ARCHITECT'S PROJECT #1708 4J SCHOOL DISTRICT CIP# 600.766.000
4J SCHOOL DISTRICT
NORTH EUGENE HIGH SCHOOL
TRACK SHED 2018
200 SILVER LANE
EUGENE, OREGON 97404

This addendum, consisting of a total of (3) pages, forms a part of the Contract Documents and modifies the original Drawings dated February 5, 2018. Acknowledge receipt of this Addendum in the space provided on the Bid Form. Failure to do so may subject the Bidder to disqualification.

SHEET NUMBER
A3

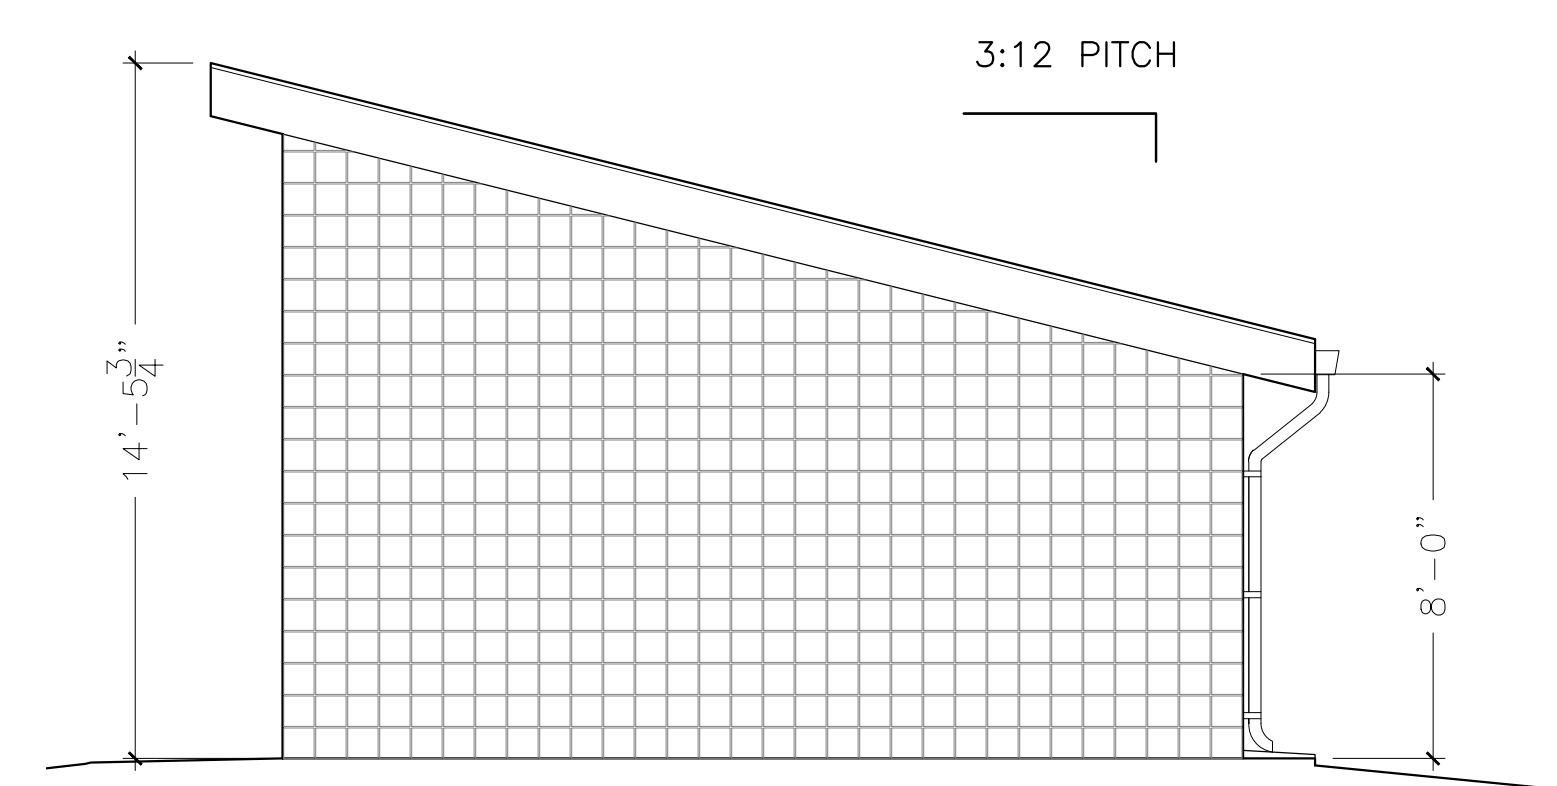
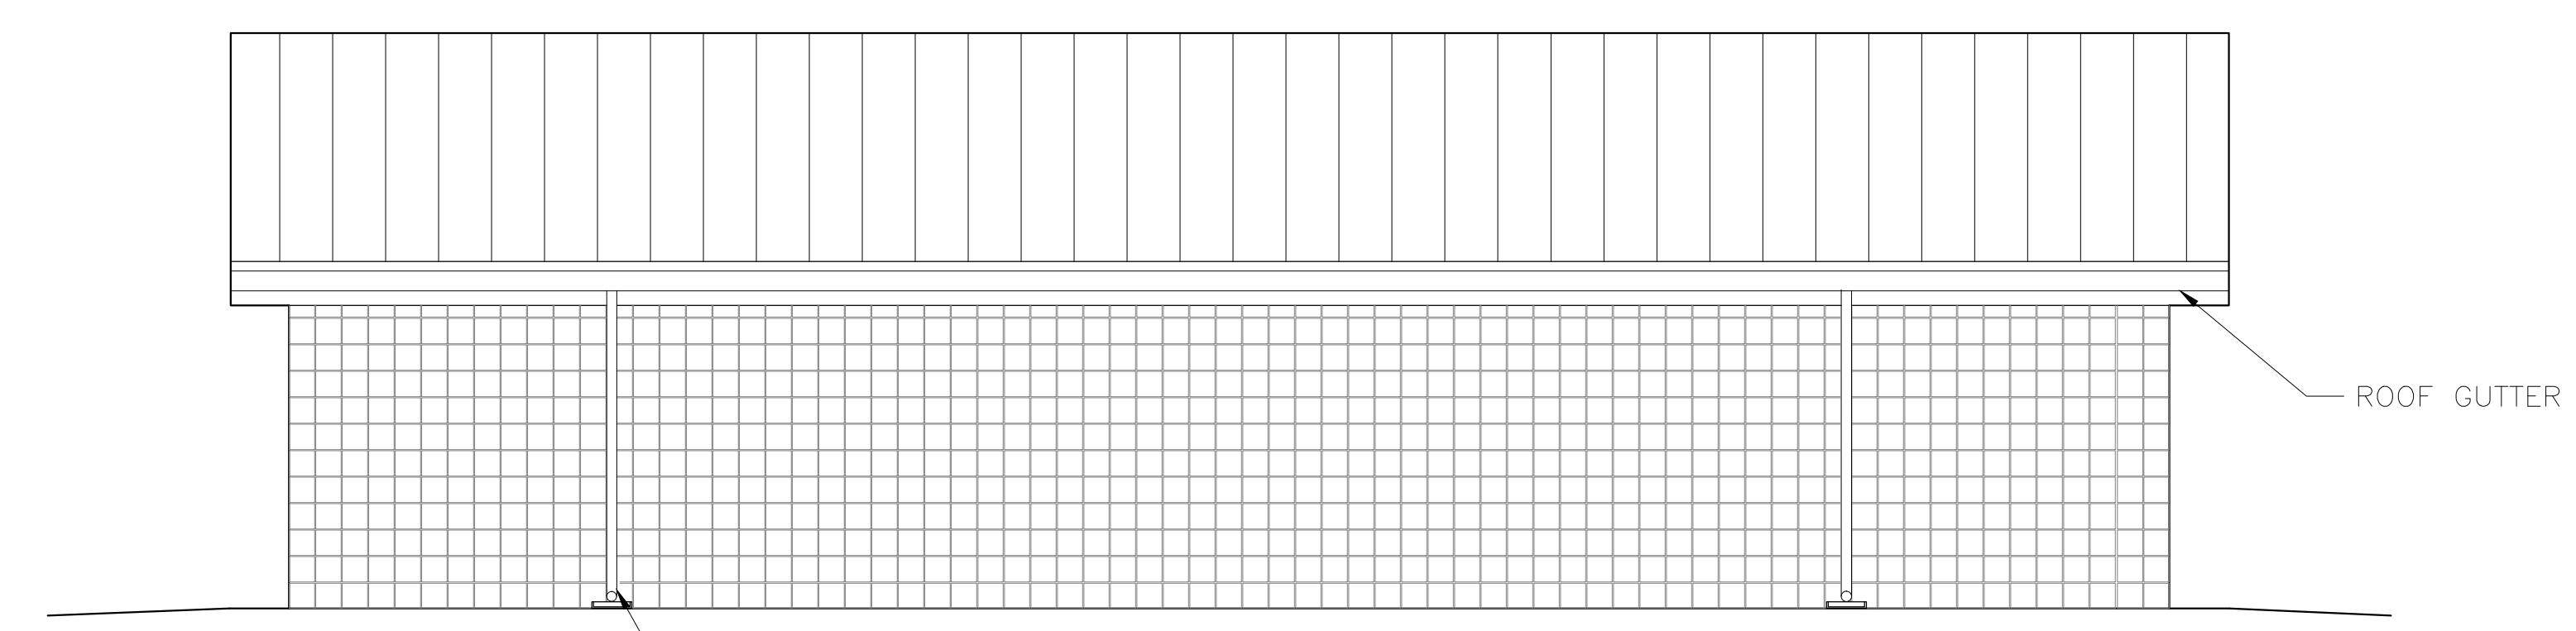
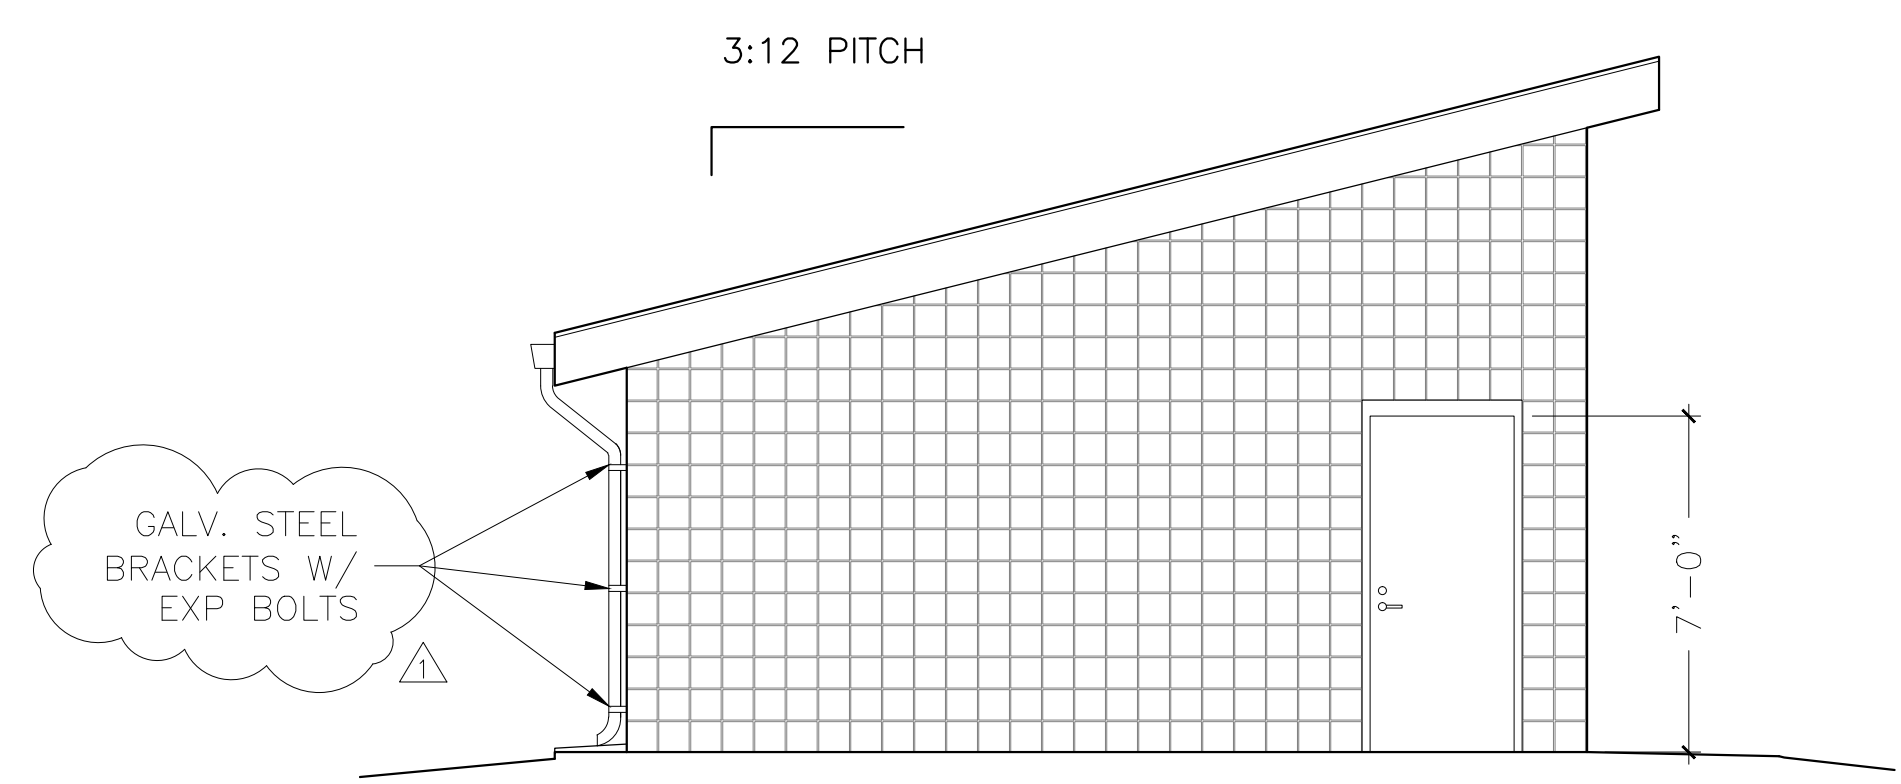
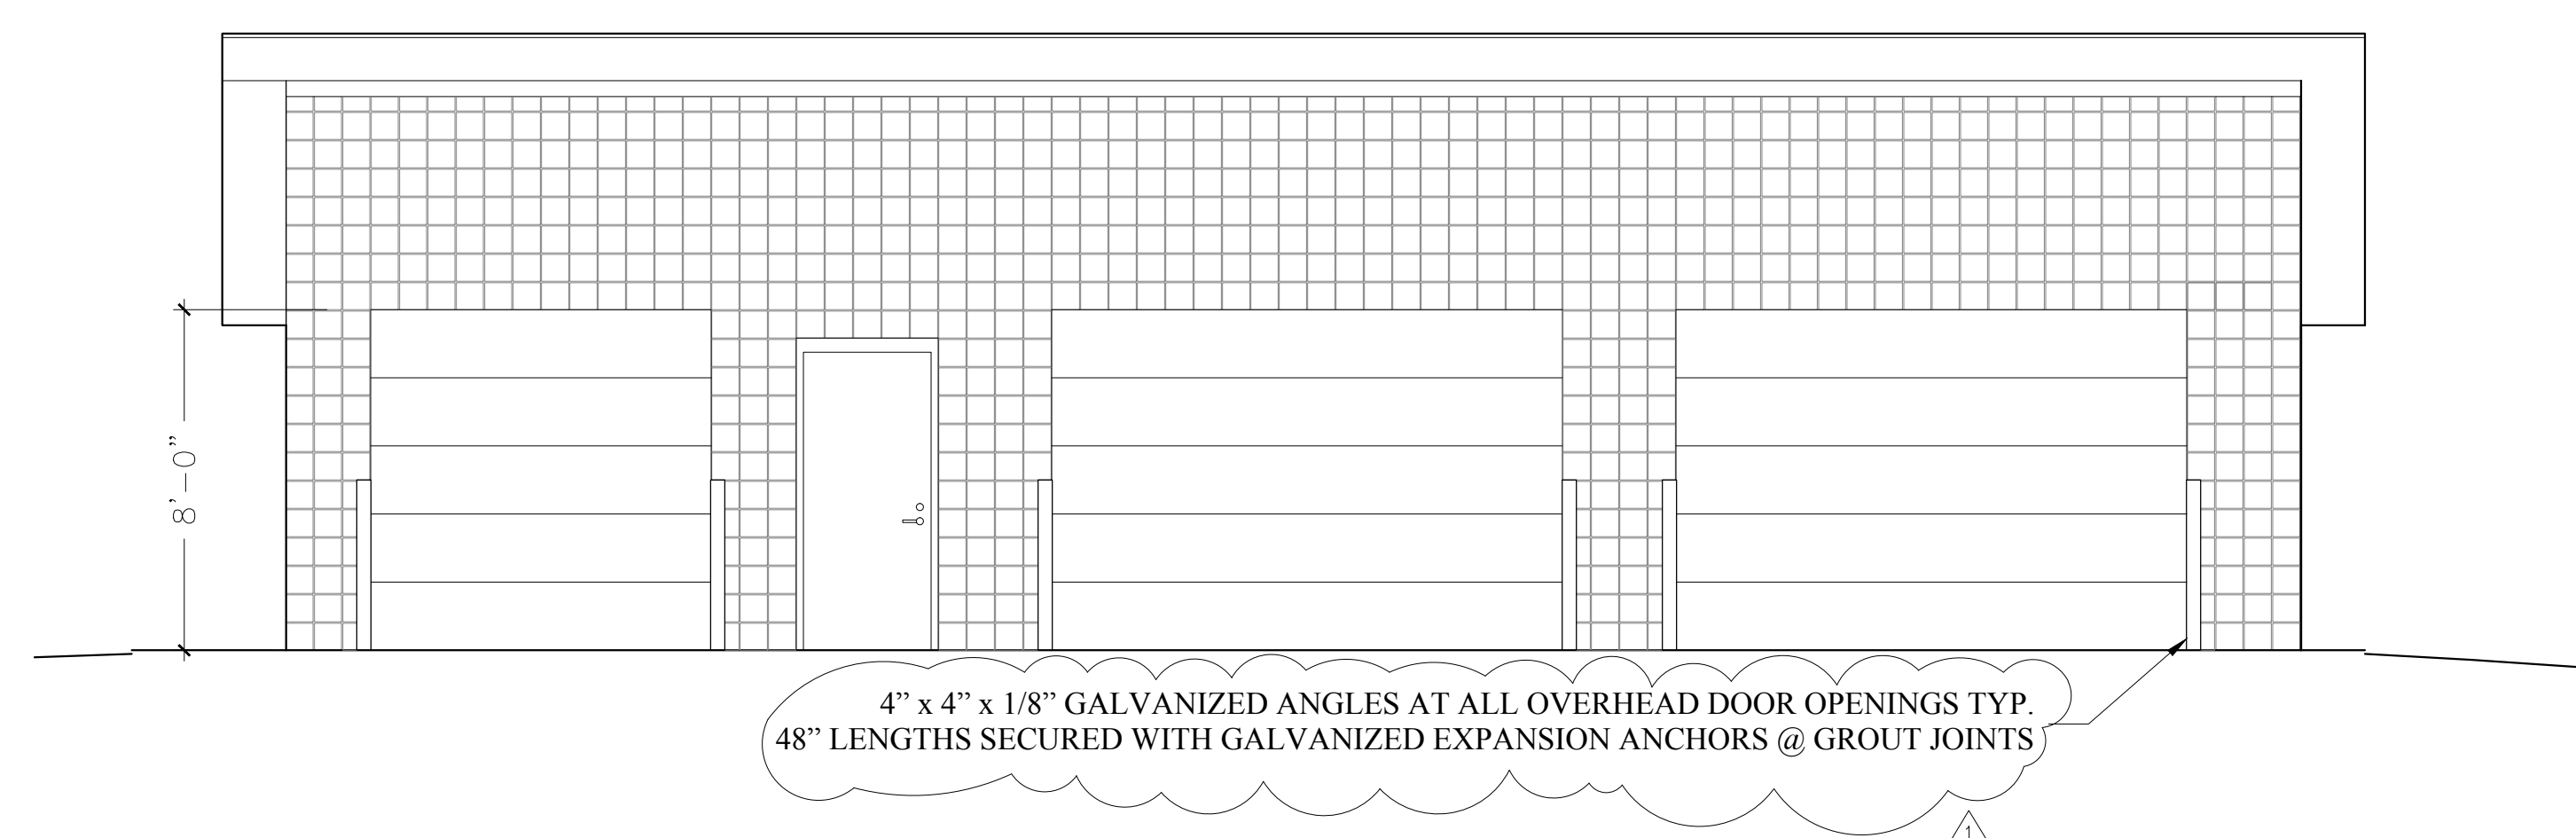
9. A3 Rev#1- Add (6) 4"x4"x1/8" galvanized angles at all exterior corners of overhead door openings. 48" lengths secured with galvanized expansion anchors.

10. A3 Rev#1- Clarification regarding gutter brackets.
11. A4 Rev#1- Addition of 9/A4 Fascia Detail.
12. A4 Rev#1- Corrections and clarifications to 6/A4 Rake Detail.

5 FOUNDATION / CORNICE SECTION DETAIL
 SCALE: 1" = 1'-0"

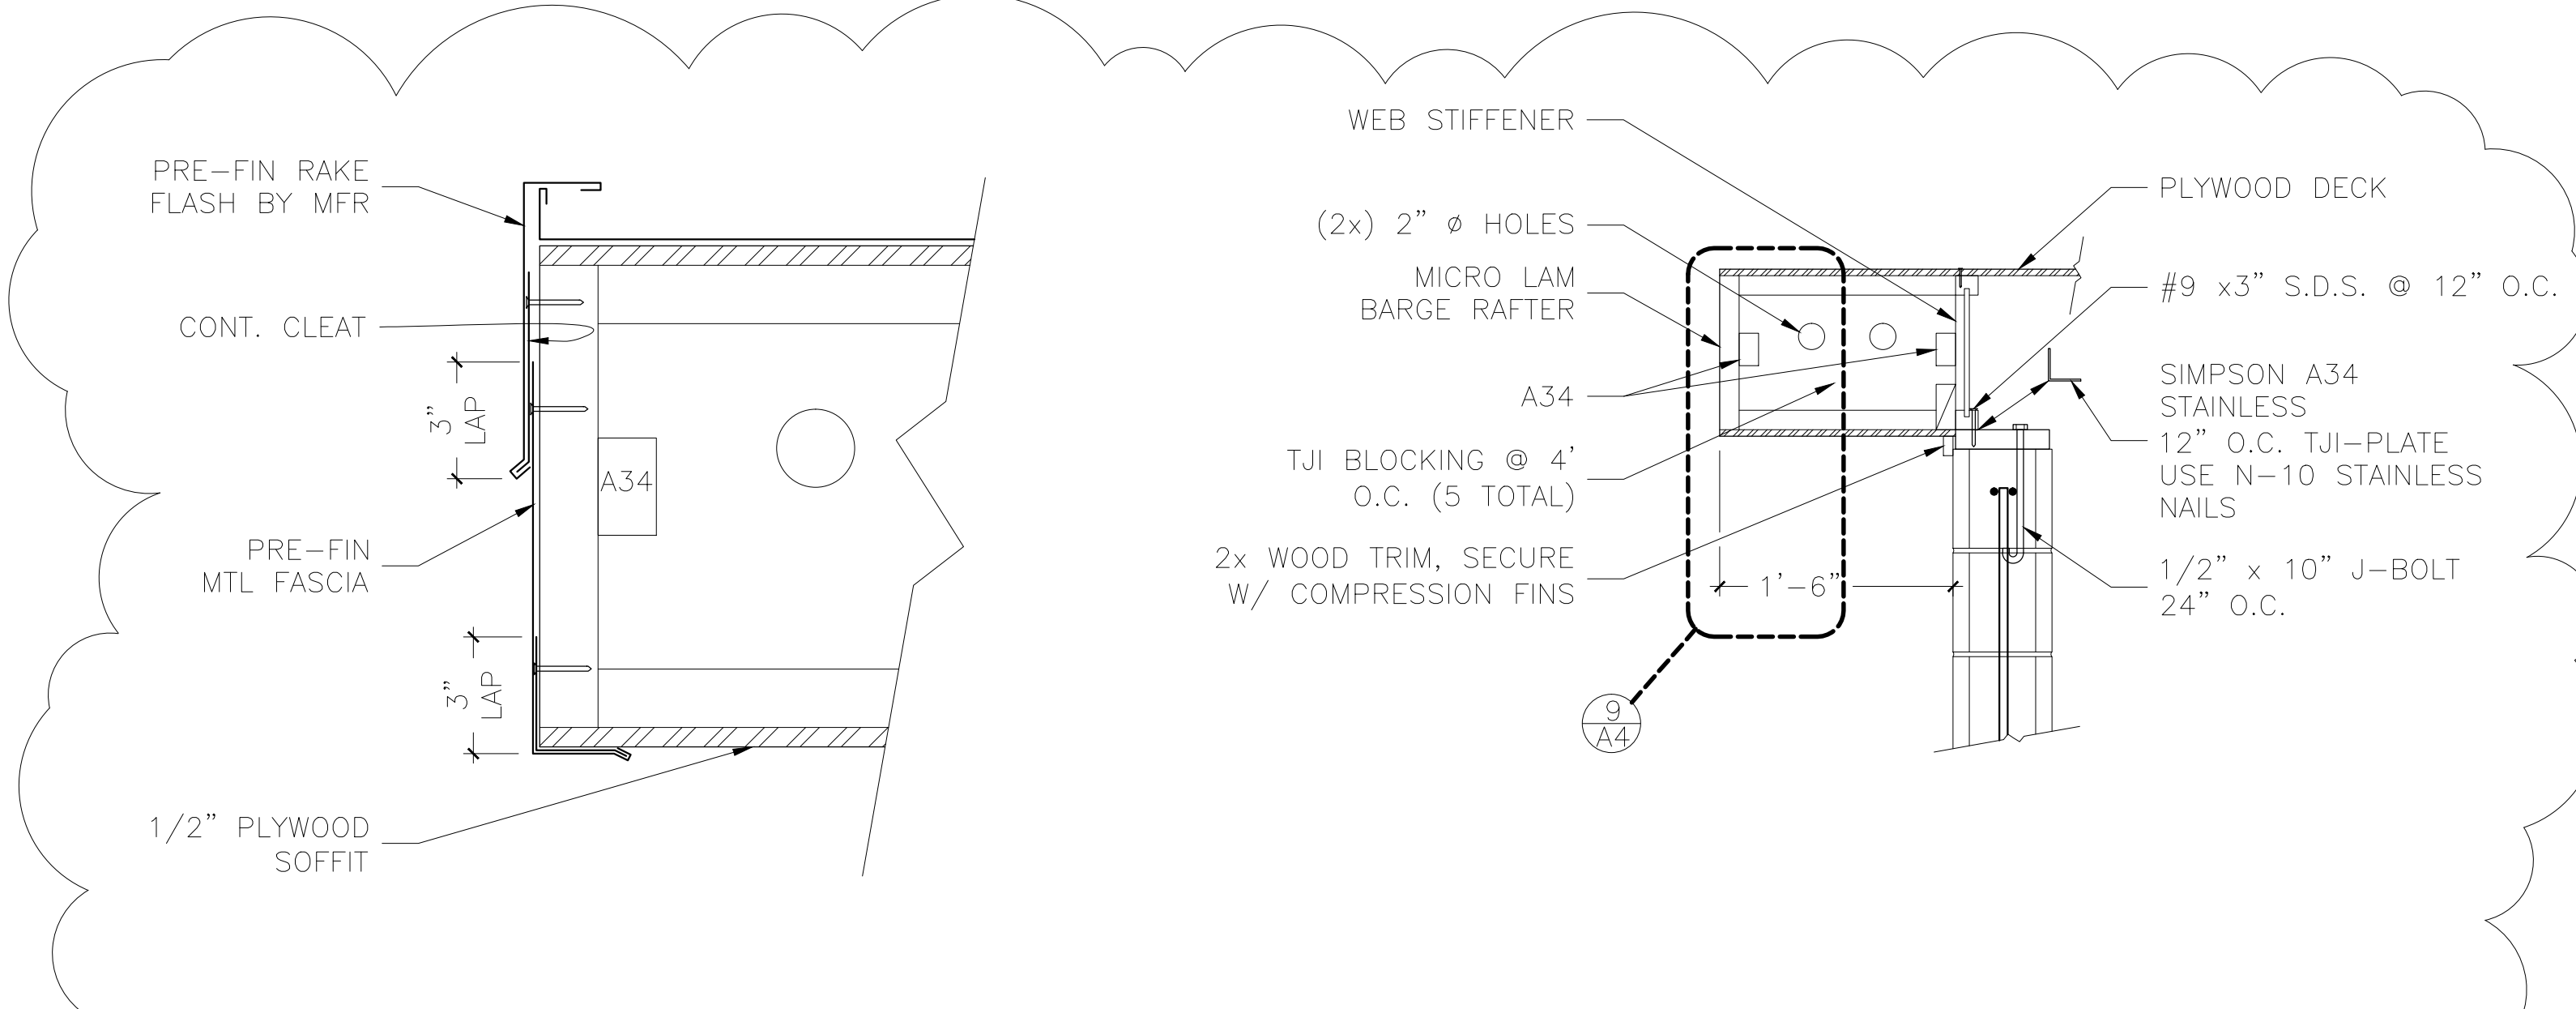
13. A4 Rev#1- Clarifications to 5/A4 Foundation/Cornice Section Detail: continuous PVC soffit vent.
14. A5 Rev#1- Clarifications to flashings in Detail 1/A5Roof Detail Peak and Gutter.
